Lane Cove Bushland & Conservation Society Inc

14 October, 2020.

LCBCS Submission: 'Proposed DCP Plan for Northwood Shops Facility – SU8095'

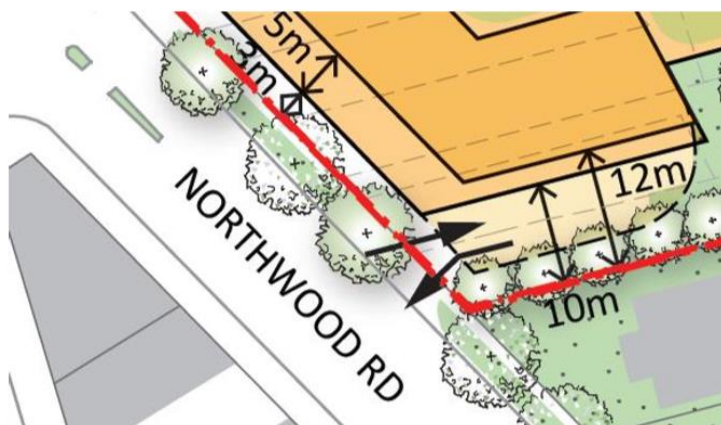
The setback and allowance for deep soil planting and root zones and canopy for mature trees at the Southern boundary seems to be inadequate to achieve the purposes of the DCP, as roads are hard surfaces, as per the sketch provided:

Transport and Parking (p9) Provisions b) *Provide landscape buffers between any vehicle access points and adjacent residential development.*
